GENERAL NOTES

GENERAL NOTES (CONTINUED)
Walker Rd./Jane Lundeen/Pinehurst
Signing and Striping Plan

LSC Responses to PCD CD Redline Comments

WALKER RD. SIGNING AND STRIPING PLAN

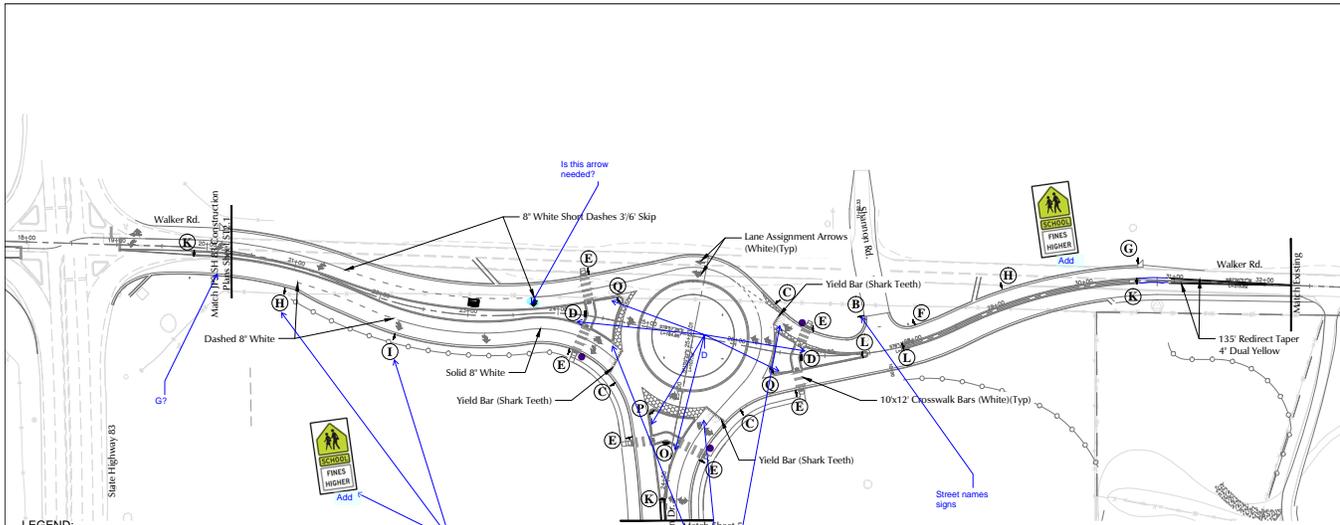
Is this arrow needed?

G?

Street names signs

Provide R6-4b in the central island opposite each entrance. Move "C" yield signs to roundabout side of ped ramps (where dots are shown)"D" signs can be on same post as street names at roundabout exits. See McLaughlin plans for example signage.

Place yield bars further back (at curb or 21 ft from edge of crosswalks)

Delete placard, add advance street name.

Provide slanted arrows up and to the right where applicable

Use fluorescent with "school" placards

delete - covered by yield sign placement

LSC Response: This is recommended along with the "ONLY" because this lane will essentially be a left "drop" lane. This was shifted west slightly.

LSC Response: Added as requested.

LSC Response: Added as requested.

Author: jchodsdon Subject: Sticky Note Date: 8/19/2020 13:22:14
LSC Response: Distances verified.

Author: jchodsdon Subject: Sticky Note Date: 8/19/2020 13:22:46
LSC Response: Revised as requested.

Author: jchodsdon Subject: Sticky Note Date: 8/19/2020 13:24:29
LSC Response: Revised as requested.

Author: jchodsdon Subject: Sticky Note Date: 8/19/2020 13:21:24
LSC Response: Deleted as requested. Added street name sign plates AA, BB and CC.

Author: jchodsdon Subject: Sticky Note Date: 8/19/2020 13:21:45
LSC Response: Revised as requested.

Author: jchodsdon Subject: Sticky Note Date: 8/19/2020 13:20:16
LSC Response: Revised as requested.

Author: jchodsdon Subject: Sticky Note Date: 8/19/2020 13:17:10
LSC Response: Deleted as requested.

PINEHURST DR. SIGNING AND STRIPING PLAN
 Walker Rd./Jane Lundeen/Pinehurst
 Signing and Striping Modifications Plan

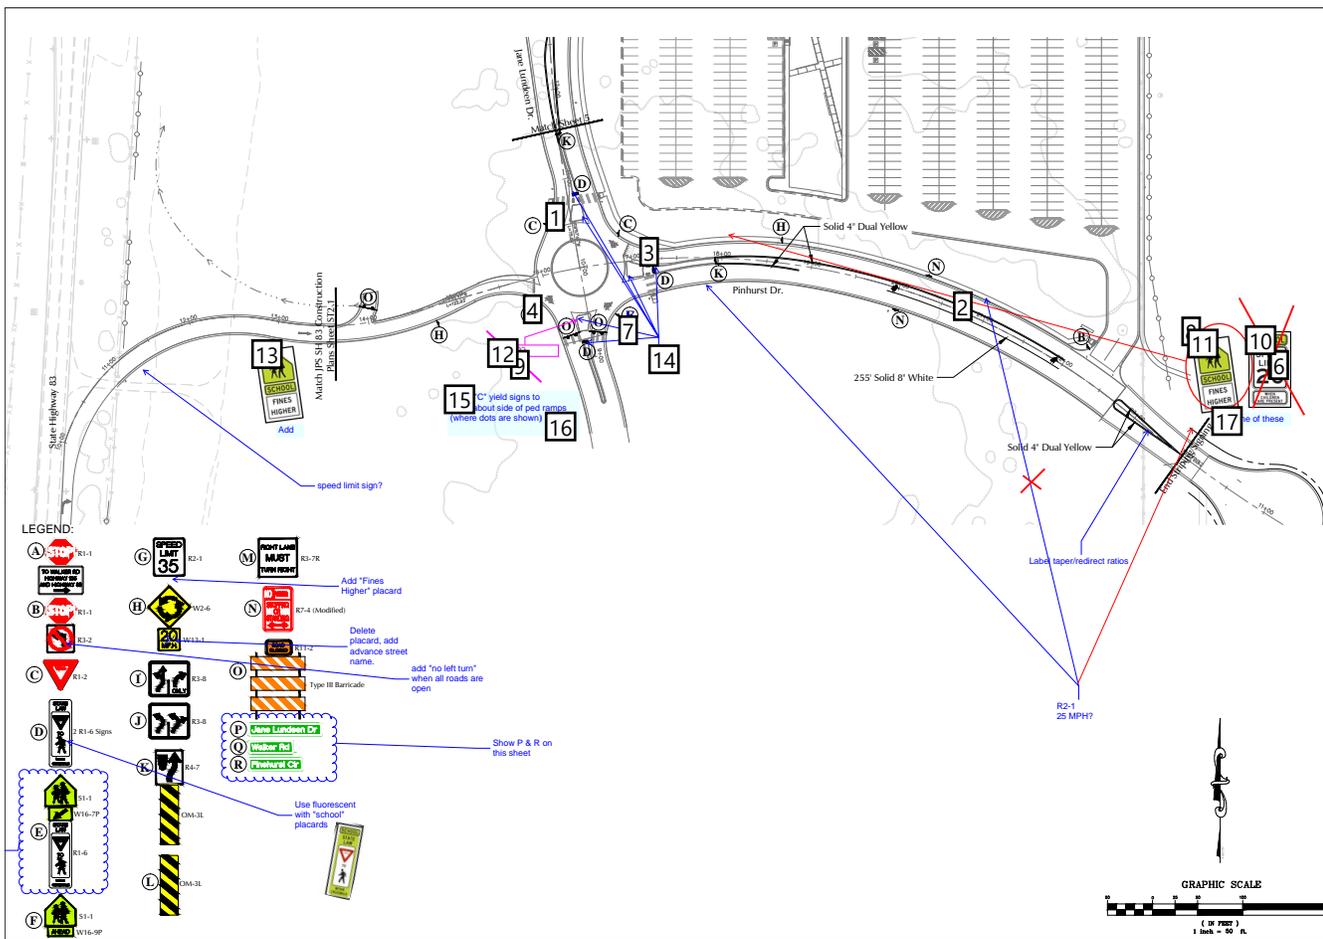
-  Number: 5 Author: dsdrice Subject: Callout Date: 8/12/2020 13:14:56
[Add "Fines Higher" placard](#)
-
-  Author: jchodsdon Subject: Sticky Note Date: 8/19/2020 13:26:46
LSC Response: Added as requested.
-

-  Number: 7 Author: dsdrice Subject: Callout Date: 8/12/2020 16:19:44
[Delete placard, add advance street name.](#)
-
-  Author: jchodsdon Subject: Sticky Note Date: 8/19/2020 13:27:17
LSC Response: Deleted as requested. Added street name sign plates AA,BB and CC.
-

-  Number: 9 Author: dsdrice Subject: Callout Date: 8/12/2020 13:10:17
[Taper double yellow back?](#)
-
-  Author: jchodsdon Subject: Sticky Note Date: 8/19/2020 13:28:39
LSC Response: Revised as requested. The updated plans show reverse curve bay tapers per ECM criteria.
-

-  Number: 10 Author: dsdrice Subject: Callout Date: 8/12/2020 16:53:35
[delete or move north?](#)
-
-  Author: jchodsdon Subject: Sticky Note Date: 8/19/2020 13:30:08
The advance ped xing sign has been shifted I up close to the Walker Roundabout on the NB approach; A speed limit sign (35 w/ Fines Higher) was added here.
-

Use fluorescent with "school" placards

delete - covered by yield sign placement

LSC Response: Revised as requested.

LSC Response: Deleted as requested.

PINEHURST DR. SIGNING AND STRIPING PLAN
Walker Rd./Jane Lundeen/Pinehurst
Signing and Striping Modifications Plan

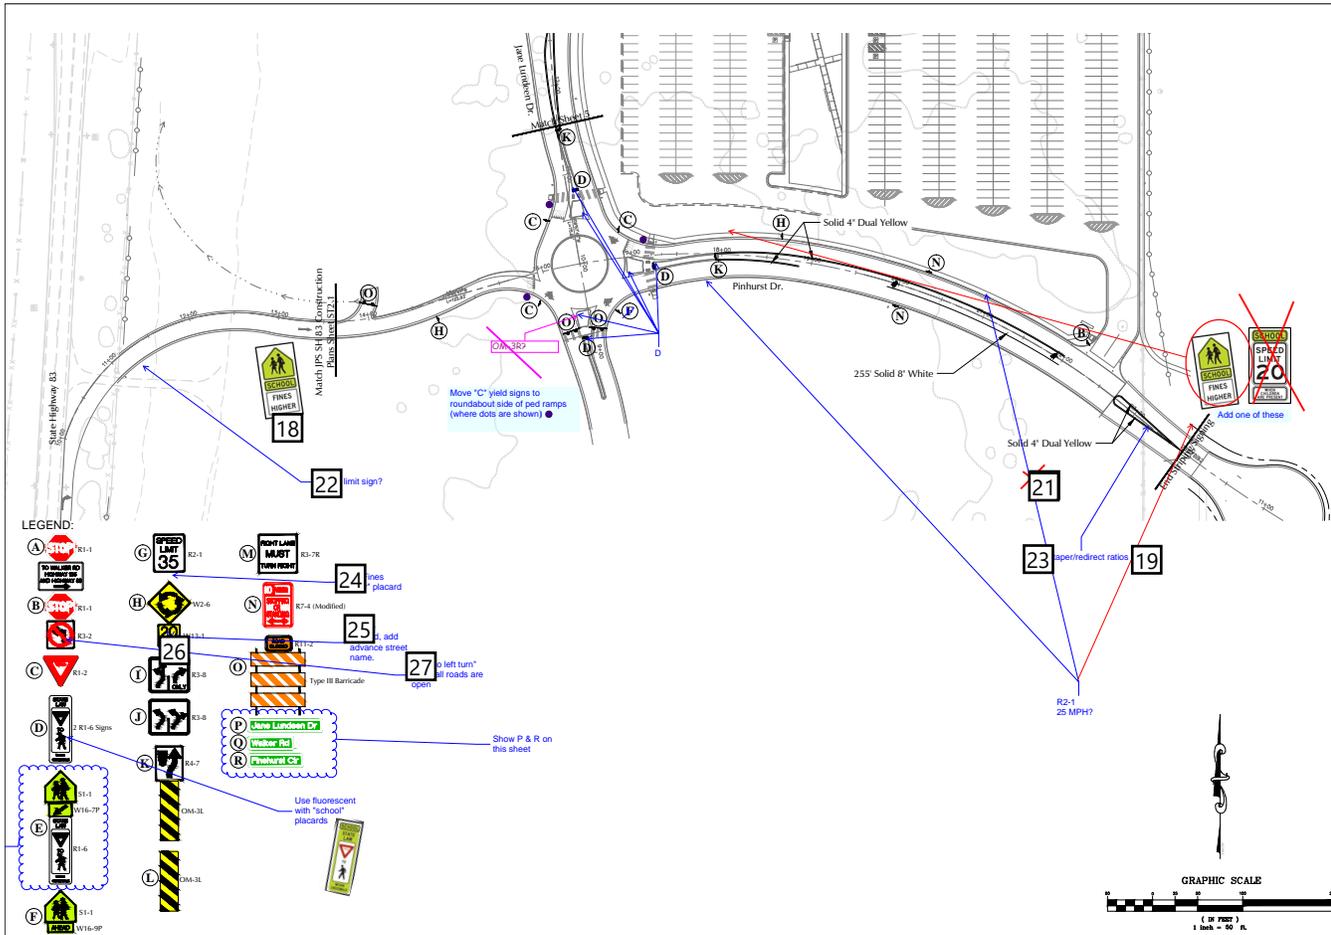
-  Number: 11 Author: dsdrice Subject: Image Date: 8/12/2020 16:29:28
-
-  Number: 12 Author: jchodsdon Subject: Callout Date: 8/17/2020 22:44:46
OM-3R? In the interim with barricaded south leg?

-  Number: 14 Author: dsdrice Subject: Callout Date: 8/12/2020 13:38:36
D
-  Author: jchodsdon Subject: Sticky Note Date: 8/19/2020 13:43:14
D signs removed on the south leg, and on the future departure leg side of the splitter island;
NOTE: The street name signs and some ped. crossing signs have been moved to alternate locations on the revised plan set so as to not conflict with the autoturn vehicle turning paths from the roundabout design report.
-

-  Number: 15 Author: dsdrice Subject: Text Box Date: 8/12/2020 16:35:04
Move "C" yield signs to roundabout side of ped ramps (where dots are shown)
-  Author: jchodsdon Subject: Sticky Note Date: 8/19/2020 13:36:57
LSC Response: Revised as requested.
-

speed limit sign?

Label taper/redirect ratios

Add "Fines Higher" placard

Delete placard, add advance street name.

add "no left turn" when all roads are open

-  Author: jchodsdon Subject: Sticky Note Date: 8/19/2020 13:41:04
Follow up - NOT included as it would conflict with Autoturn vehicle turning paths.
-
-  Number: 13 Author: dsdrice Subject: Image Date: 8/12/2020 16:30:07
-

LSC Response: We shifted the advance ped warning sign to the west on the approach to the roundabout

Instead of the 20 mph school speed zone sign depicted in these comments, the 25 mph sign w/ Fines Higher is shown in this location upstream of the school access.

A 20 mph speed limit sign is shown on the JPS signing & striping plans for SH 83. John's plans. The match line note includes a reference to those plans.

LSC Response: Added as requested.

LSC Response: Added as requested.

LSC Response: Deleted as requested. Added street name sign plates AA, BB and CC.

LSC Response: This has been added.

PINEHURST DR. SIGNING AND STRIPING PLAN
 Walker Rd./Jane Lundeen/Pinehurst
 Signing and Striping Modifications Plan

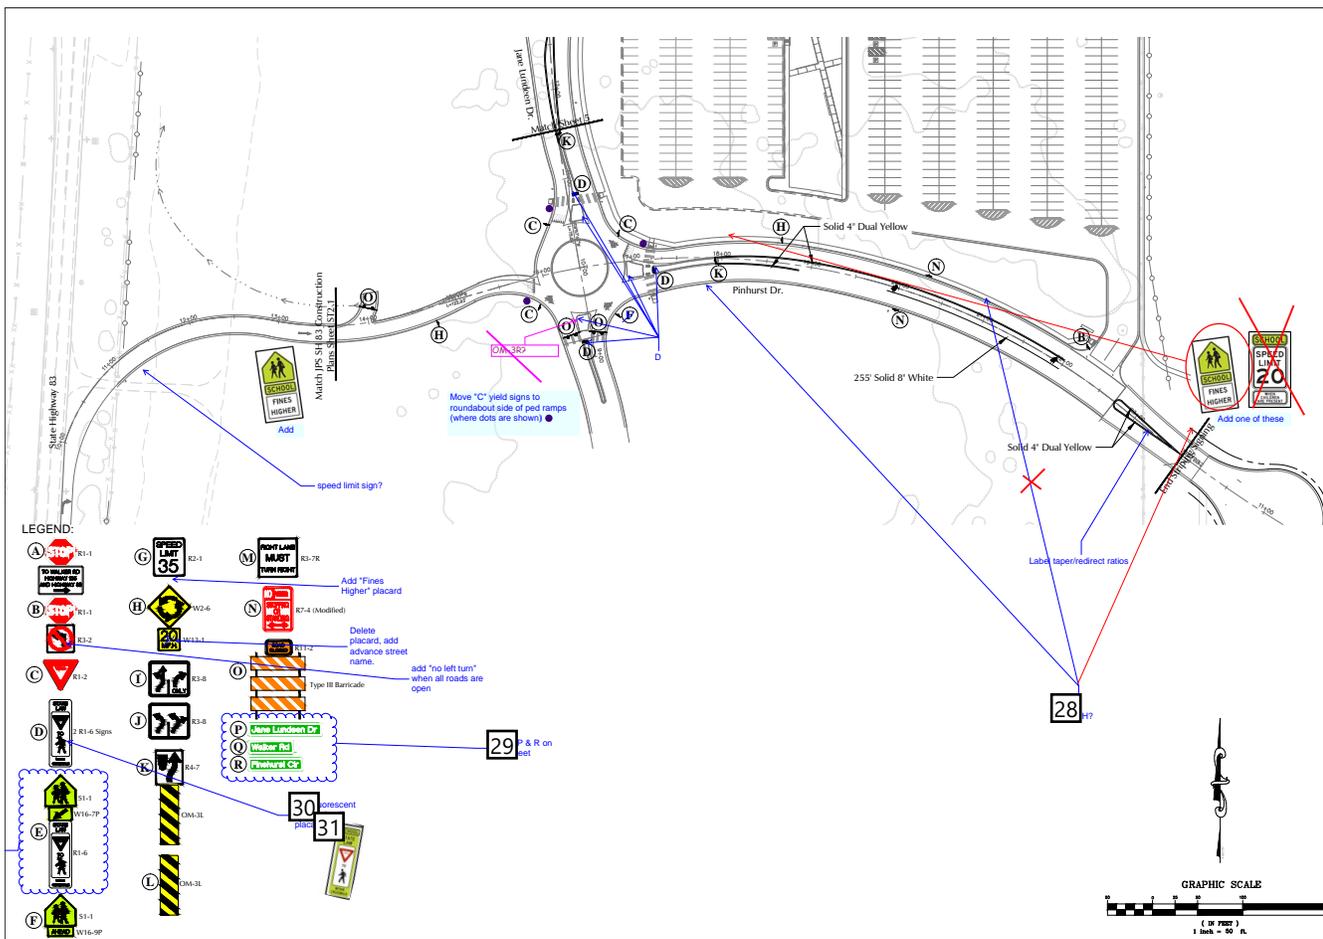
R2-125 MPH?

Show P & R on this sheet

Use fluorescent with "school" placards

delete - covered by yield sign placement

LSC Response: Added as requested, but placed upstream of the school access (westbound direction).

LSC Response: Added as requested. NOTE: The street name signs and some ped. crossing signs have been moved to alternate locations on the revised plan set so as to not conflict with the autoturn vehicle turning paths from the roundabout design report.

LSC Response: Revised as requested.

LSC Response: Deleted as requested.
